APPENDIX C

RESPONSE TO AGENCY COMMENTS
ON THE DRAFT FINAL REPORT

RESPONSE TO COMMENTS ON THE
DRAFT FINAL TRACK 1 ORDNANCE AND EXPLOSIVES
REMEDIAL INVESTIGATION/FEASIBILITY STUDY
FORMER FORT ORD, CALIFORNIA
DATED JUNE 2003

- I. JOHN D. CHESNUTT, REMEDIAL PROJECT MANAGER, UNITED STATES ENVIRONMENTAL PROTECTION AGENCY, REGION IX, 75 HAWTHORNE STREET, SAN FRANCISCO, CALIFORNIA 94105, COMMENTS DATED JULY 11, 2003

**Site Walk
Site OE-13A
March 7, 2004**

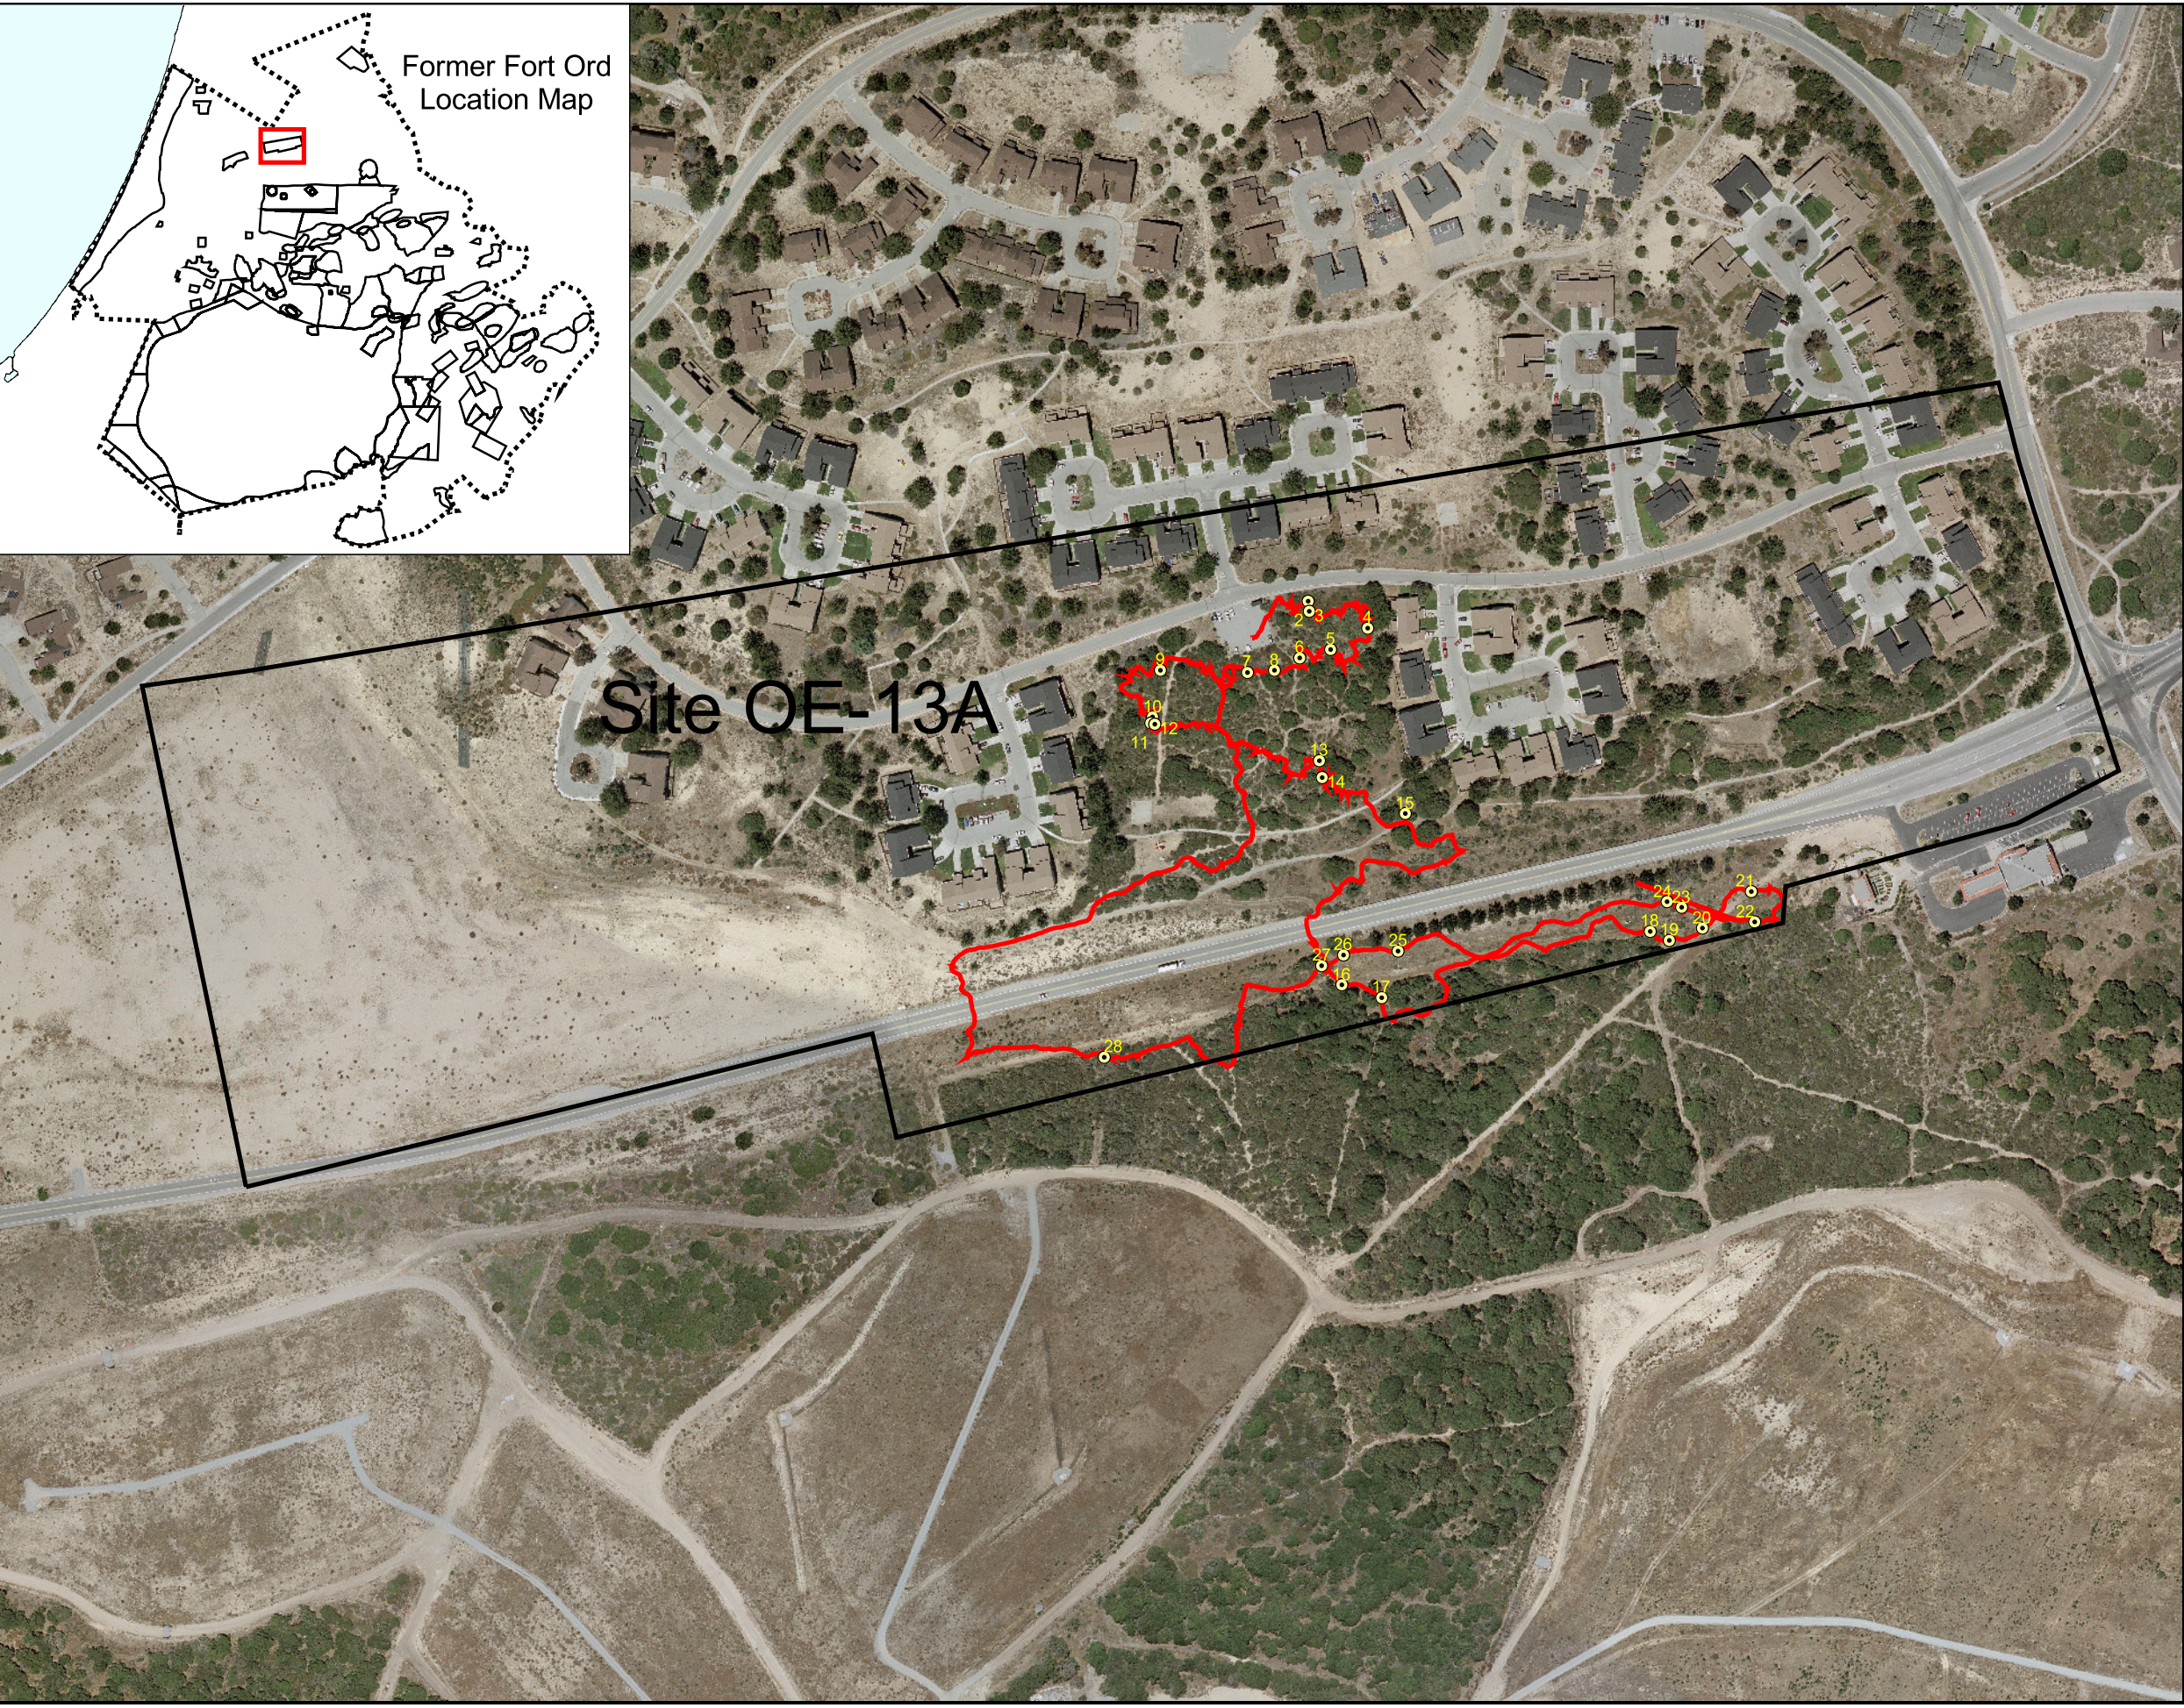
The designation of this site as Track 1 cannot be supported without additional data. The descriptive information concerning the sampling activities and the potential OE use within the area has been expanded significantly. However, the fact still remains that the western three-fourths of the area has not been sampled, and this is the portion of the area in the closest proximity to the offsite locations where ordnance items have been found. Until additional ordnance investigation is accomplished in the western three-quarters of the area, the potential for undiscovered ordnance to remain there will be unknown. This uncertainty requires that the designation of the site as Track 1 be withheld until a satisfactory investigation determines that no ordnance is present.

Response 5: Although the western $\frac{3}{4}$ of Site OE-13A was not sampled by an OE contractor, this area has undergone extensive soil disturbance over time without turning up any evidence of OE from past military training. As discussed in the draft final Track 1 report, these activities included excavation and re-grading of landfill Area A and construction of Abrams housing. In all, approximately 42 acres have been either excavated or graded within the boundary of Site OE-13A.

These soil disturbance activities, together with OE sampling conducted by HFA and CMS covered over 70% of Site OE-13A, but excluded the central portion of the site. A follow-up investigation of this undisturbed area was completed in January 2004 (site walk). The site walk was conducted by a three-person team, which included a UXO safety specialist. The team swept the path walked using a Schonstedt Model GA-52/Cx magnetometer. The path walked was also recorded using a GPS unit. All anomalies identified were investigated using hand tools. In addition, Imjin Road passes through the southern portion of Site OE-13A (Plates 13A-3 through 13A-5). The site walk information is provided as an attachment to this appendix, and the final Track 1 report has been revised to include the results of the site walk. Items found during the site walk included an M69 training mortar (OE-scrap), empty M1 ammunition clips, and non-OE scrap. The results of the site walk support the recommendation that no further OE-related investigation is necessary at Site OE-13A.

**Site Walk
Sites OE-5 and OE-59A
November 13, 2003**

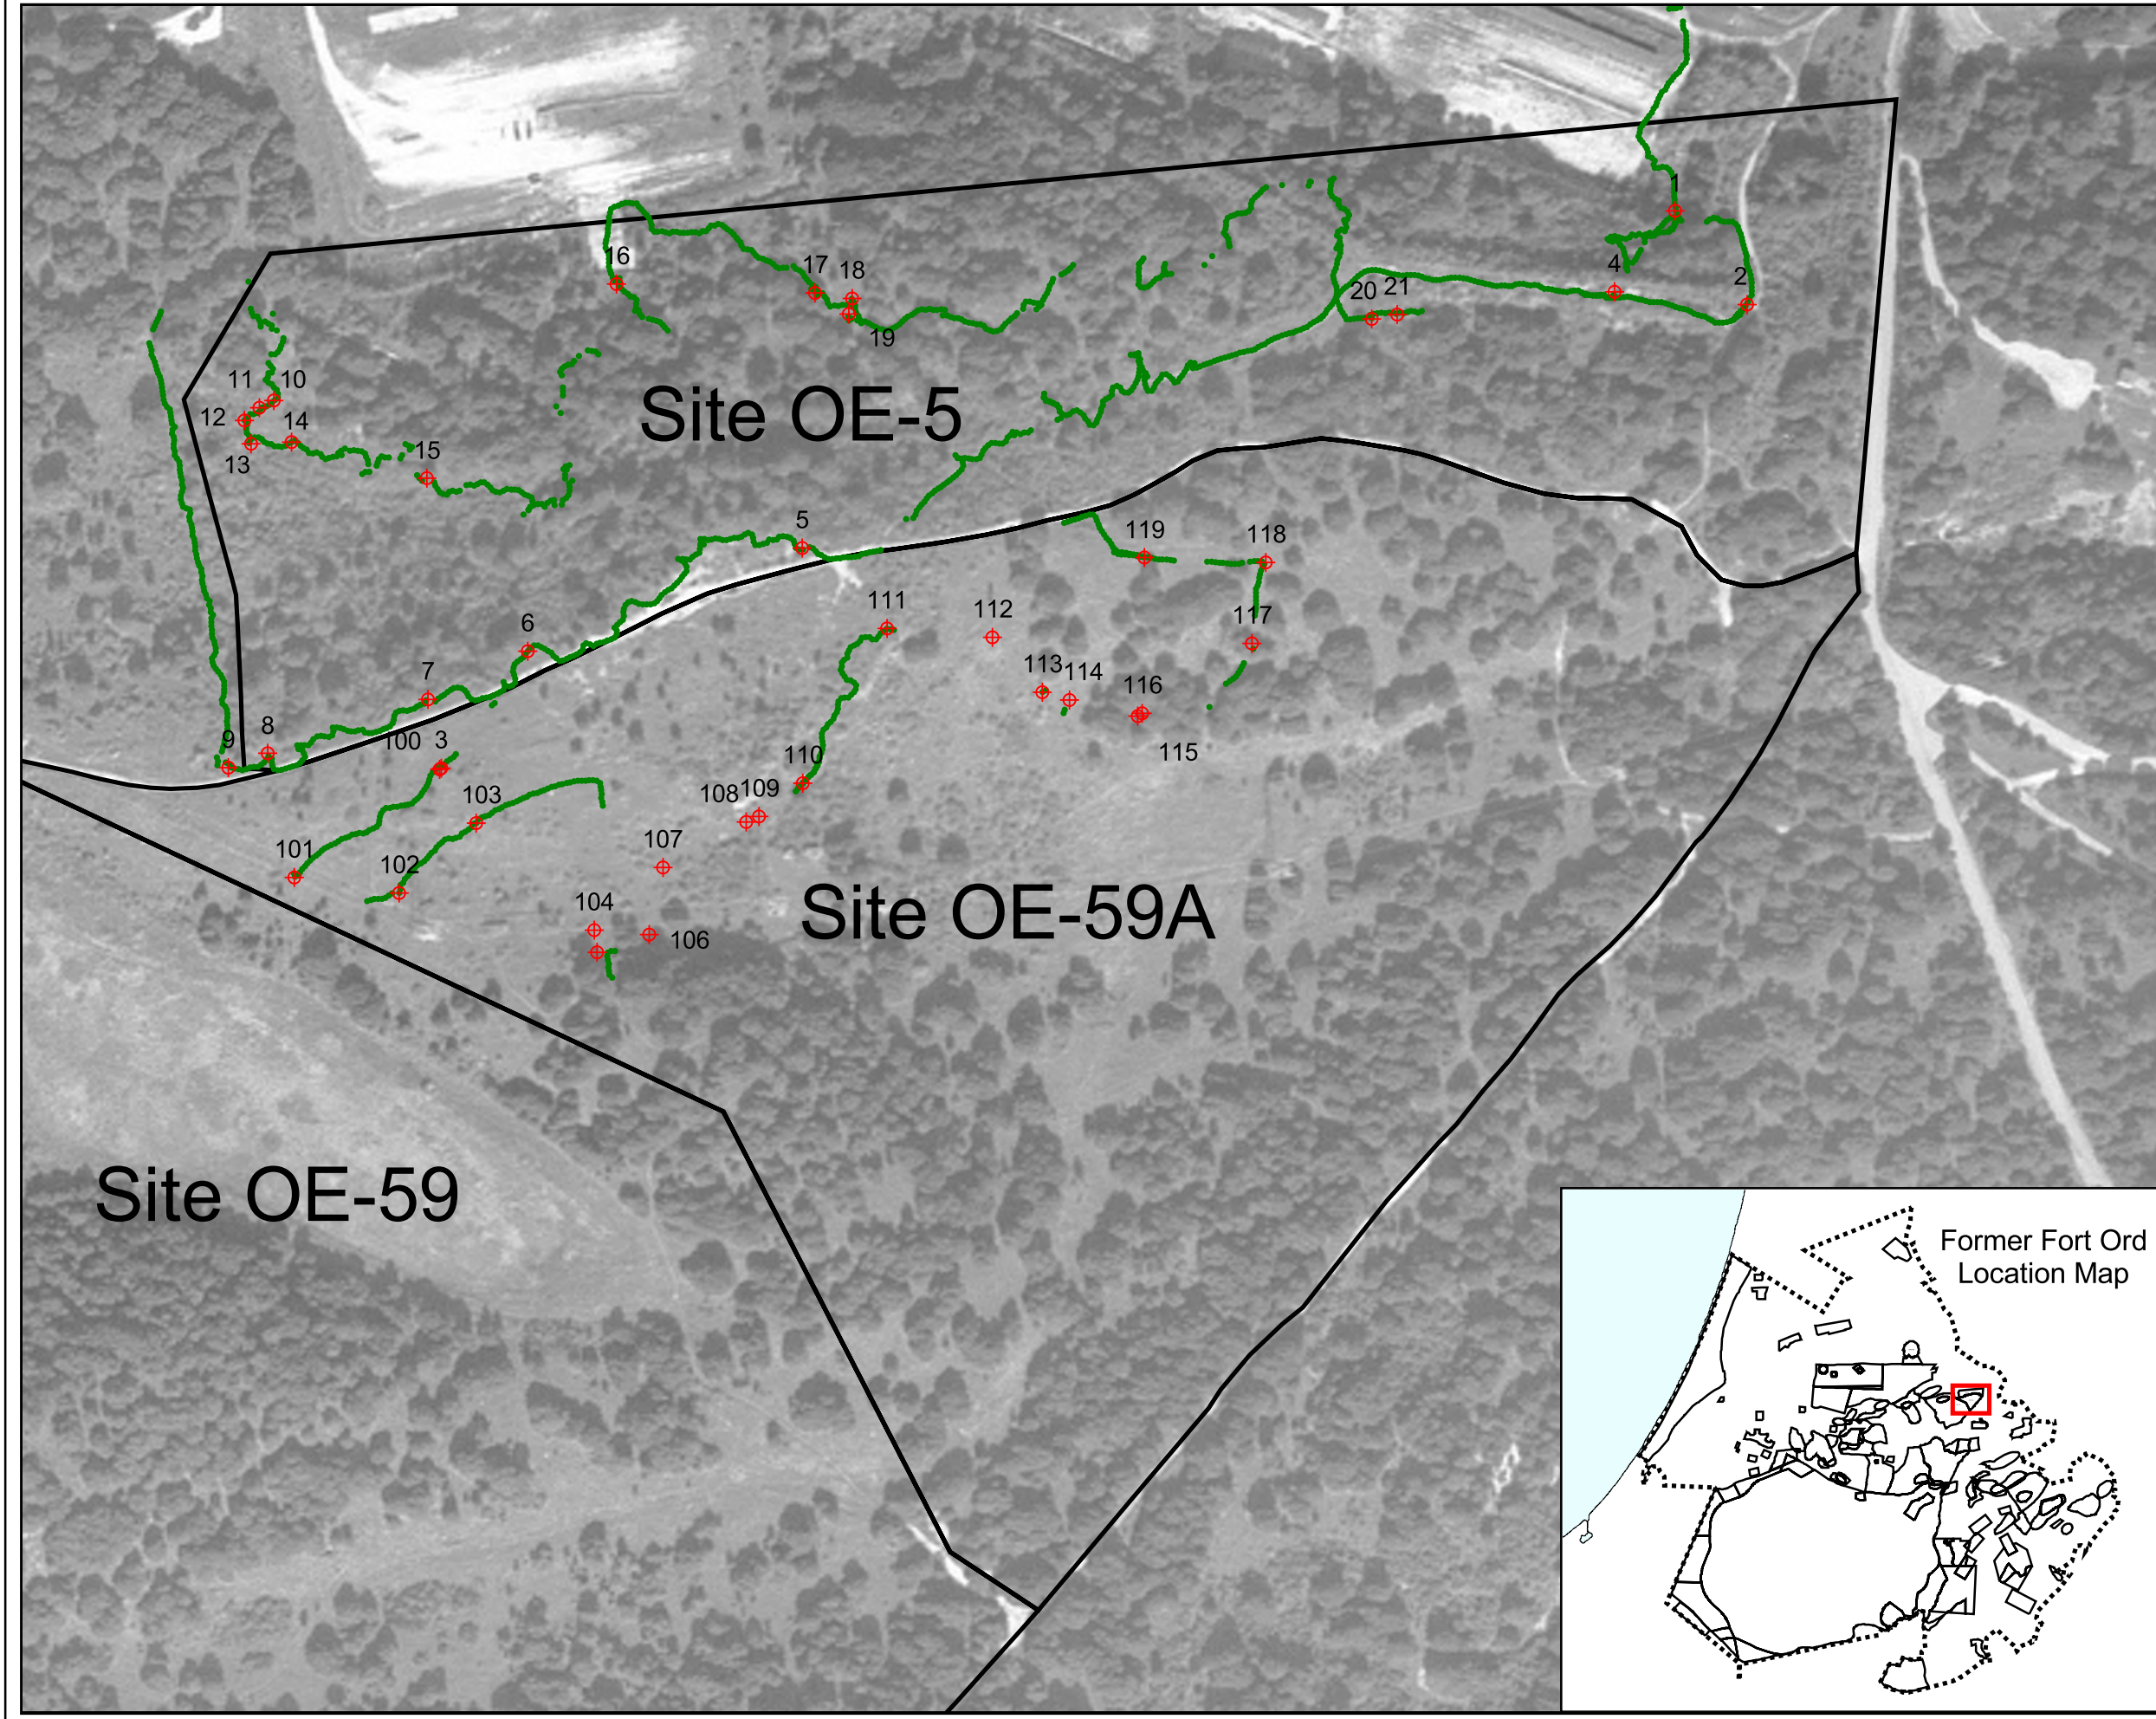
Comment 3: Site OE-5 (South of East Garrison)

Comment 24: **Site OE-59A (Unnamed)**

Response 3: The text for Site OE-5 has been revised to incorporate the results of the site walk conducted in November 2003. A report documenting the site walk is included as an attachment to this Appendix. The results of the site walk support the recommendation that no further OE-related investigation is necessary at Site OE-5.

Response 24: Additional investigation of this site was conducted in November 2003 (site walk). The text has been revised to include the results of the site walk and a report documenting the site walk is included as an attachment to this Appendix. The results of the site walk support the recommendation that no further OE-related investigation is necessary at Site OE-59A.
